AMENDMENTS TO THE DRAWINGS:

REMARKS

FIG. 1

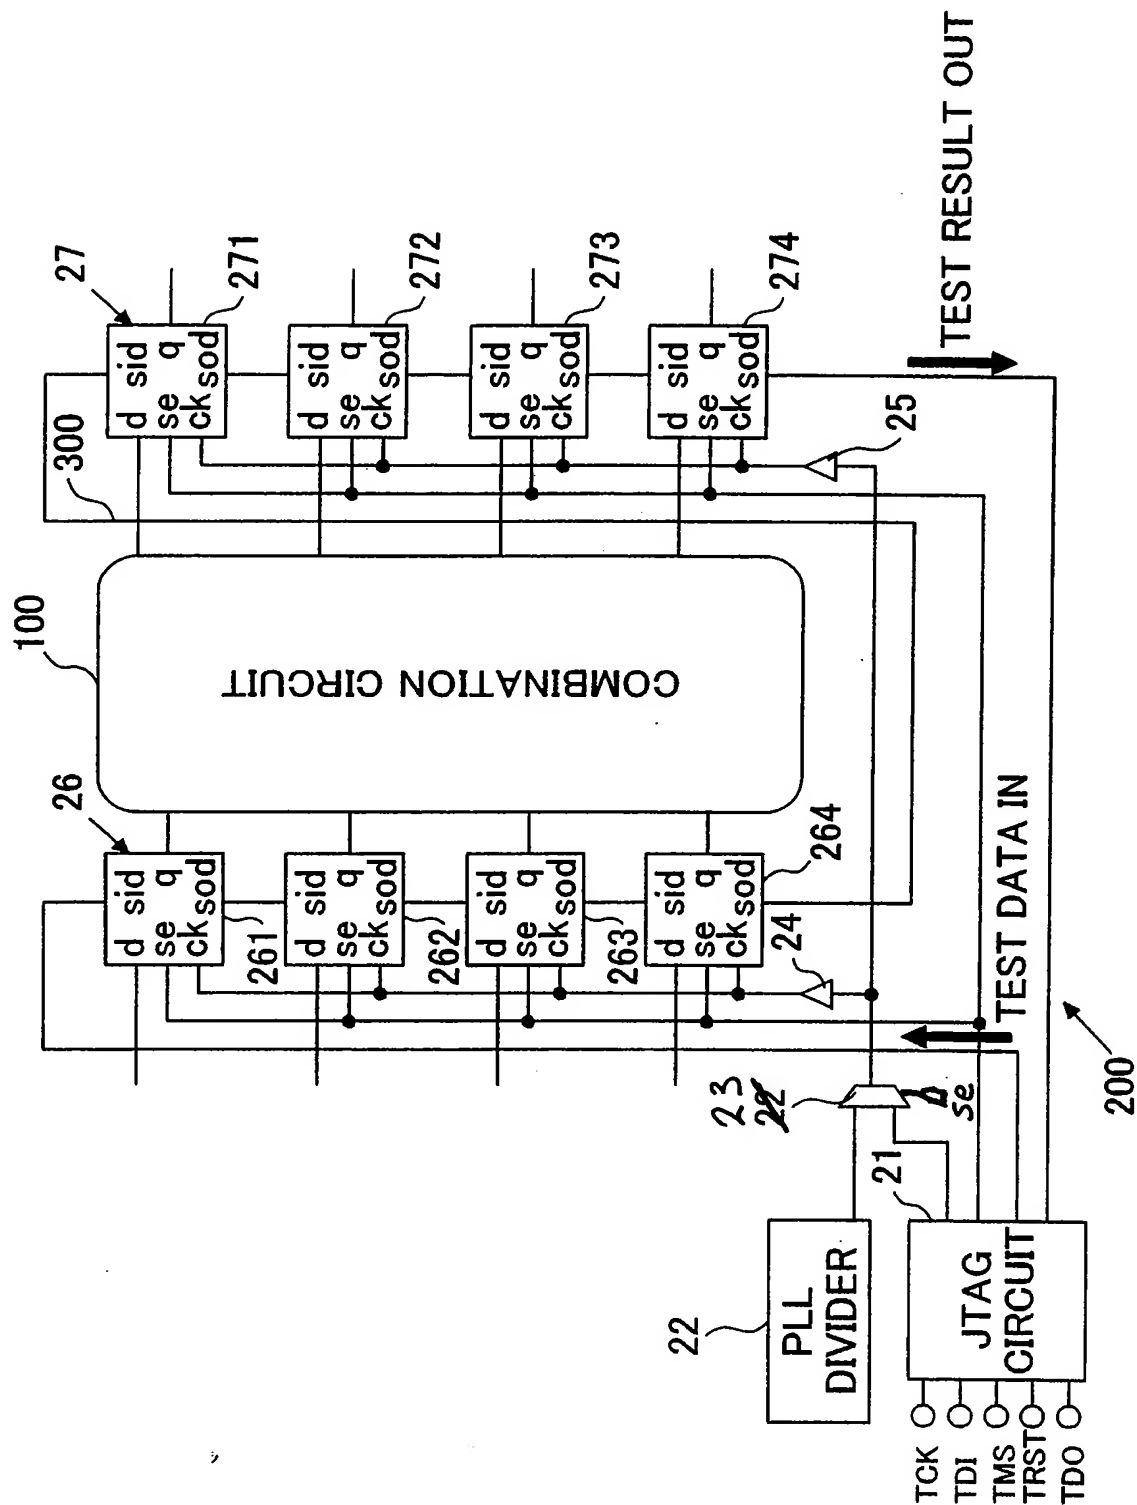
Please substitute the attached replacement sheets for Figures 1 and 10 of the drawings as originally filed.

Figures 1 and 10 have been revised to address the objections. Regarding the objection to Figures 2, 5, 6, and 11 under 37 C.F.R. § 1.84(o), Applicant sees no reason to amend the drawings as filed. Applicant understands that, according to 37 C.F.R. § 1.87(o), suitable descriptive legends may be required by the Examiner where necessary for understanding of the drawing. However, standard schematic symbols have been used in these figures, which are also clearly described in the specification. Thus, additional legends are not seen as necessary for the understanding of the above-mentioned figures. Accordingly, Applicant respectfully requests that the objection to Figures 2, 5, 6, and 11 be withdrawn.
